## Amendment #1:

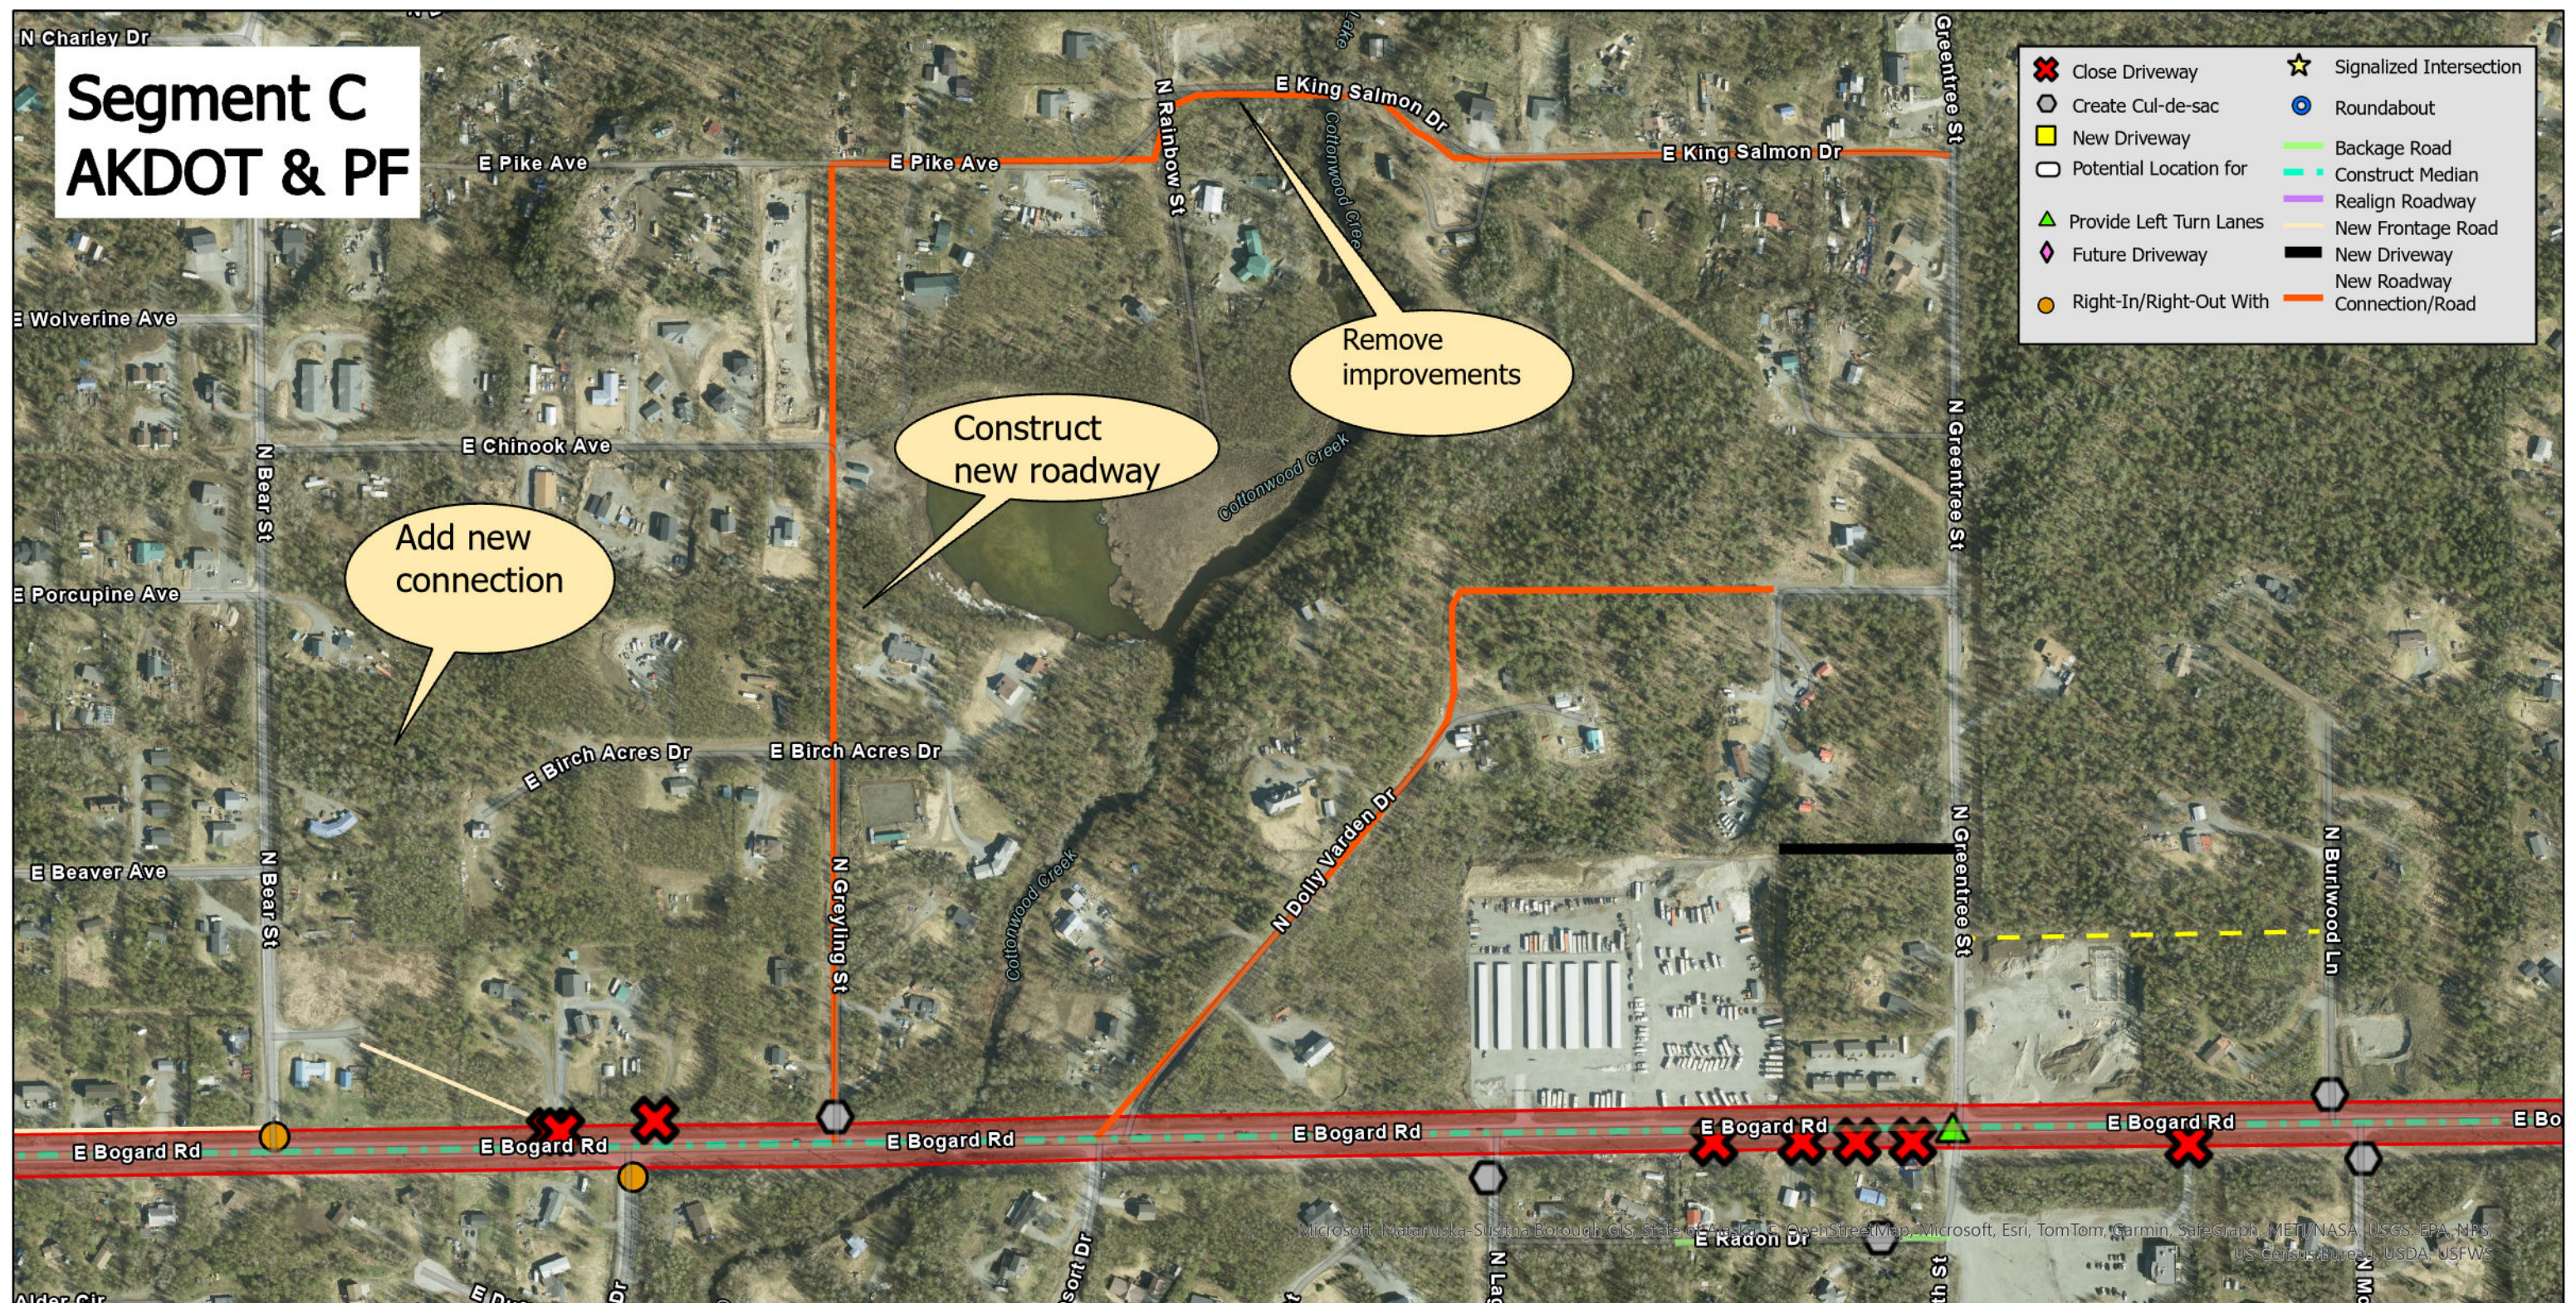
1. Remove the following language from Section 4.4.4.10, pg. 30:

"Cul-de-sac E Ashmore Avenue connection to E Bogard Road. Access to be maintained via Ashmore Avenue and N Green Forest Drive."

Remove map symbols (Fig. 4, pg. 33) for cul-de-sac at **E. Ashmore Avenue**. Add closure symbol on the map for the closure of the current entrance to the Finger Lakes State Park Road (Fig. 4, pg. 33).

1. Ashmore is approximately 720-feet from proposed alignment of Engstrom Rd. Preferred spacing is 1,320-feet. Staff supports amendment given AKDOT&PF proposed HSIP improvements.

2. Closure symbol at entrance to Finger Lake State Park was inadvertently omitted. Recommend adopting this amendment.

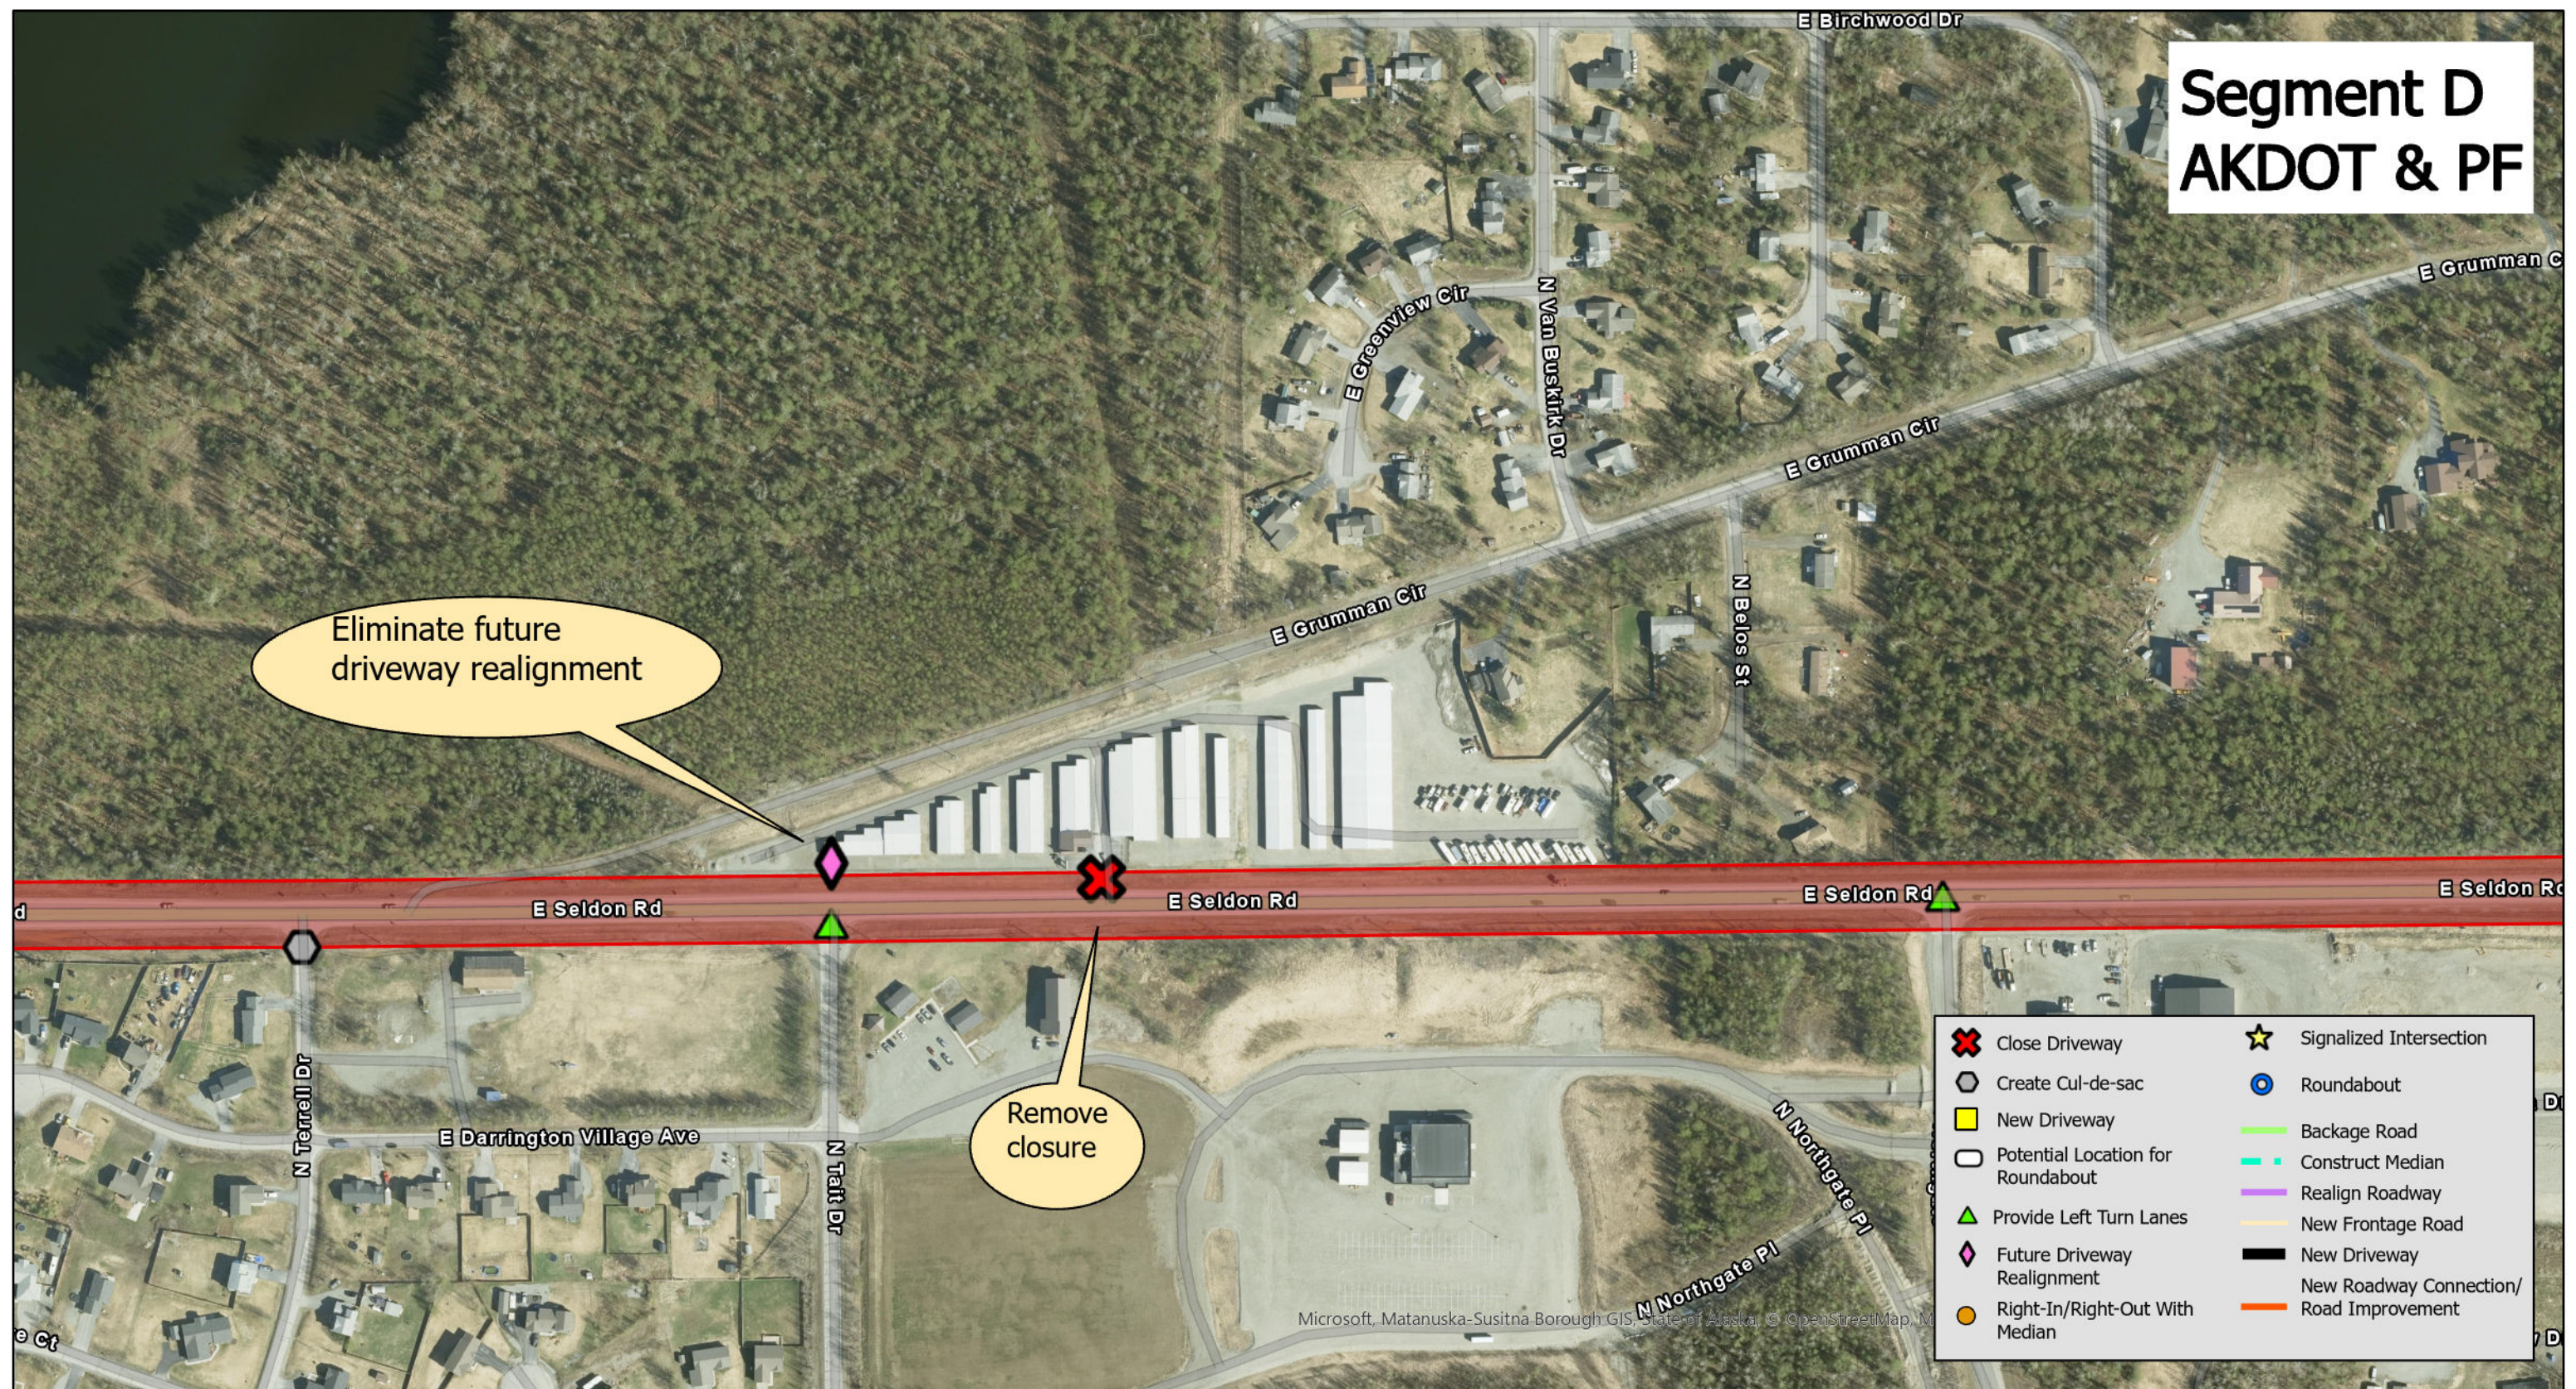
2. Add map symbols (Fig. 5, pg. 35) to indicate new roadway connection from E. Birch Acres to N. Bear St. and N. Greyling Street, from E. Birch Acres to E Chinook Avenue.

3. Remove the following language from Section 4.4.4.7, pg. 29:  
 "Improve E Pike Avenue and E King Salmon Drive to meet MSB road standards from N Bear Street to N Loris Way.  
 a. Challenges improving to E Pike Avenue to E King Salmon Drive may arise due to non-conforming parcels in this subdivision."

Remove map symbols for Road Connection/Improvement from E. King Salmon Drive to E Pike Avenue (Fig. 5, pg. 35).

1. Connection from E Birch Acres to Bear and north to Chinook are likely more feasible than improving E Pike and King Salmon.
2. Recommend adopting these amendment with preference given to constructing N. Greyling to E Chinook Ave

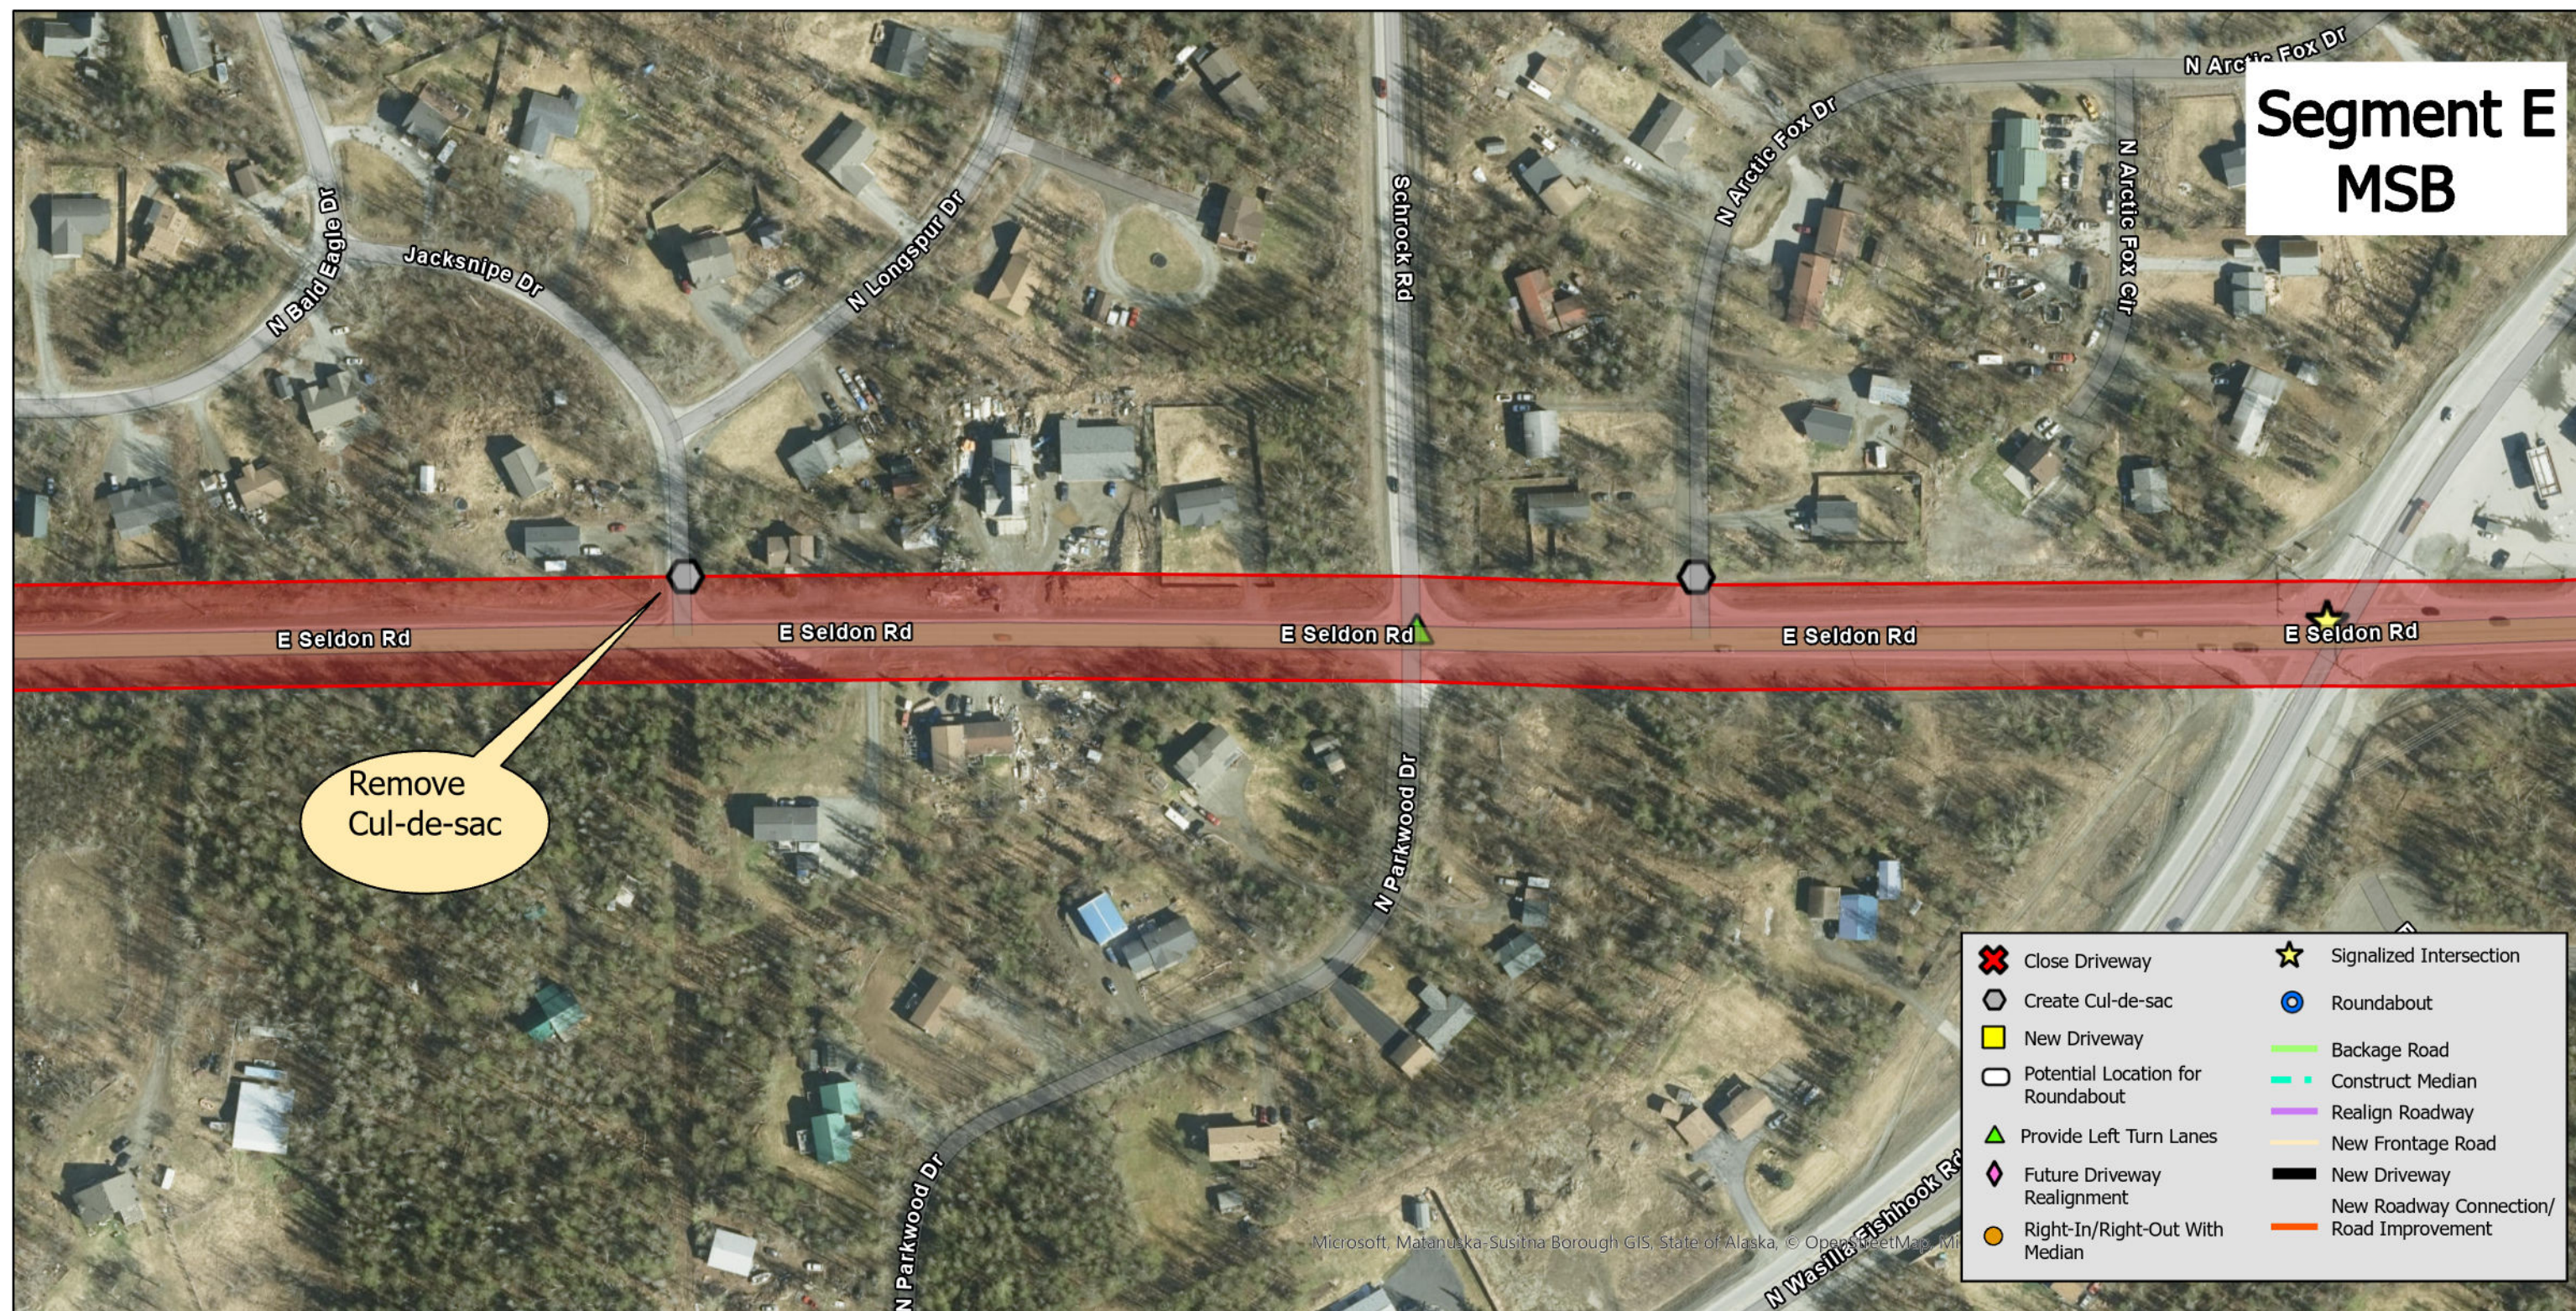
4. Remove recommendation and map symbols for Tax ID: 7592000L001 driveway access realignment with Tait Drive in Section 4.5.4.5, pg. 38.

Driveway is currently offset with N. Tait Dr. by 418 feet. A major goal of the CAMP is to realign minor approaches.
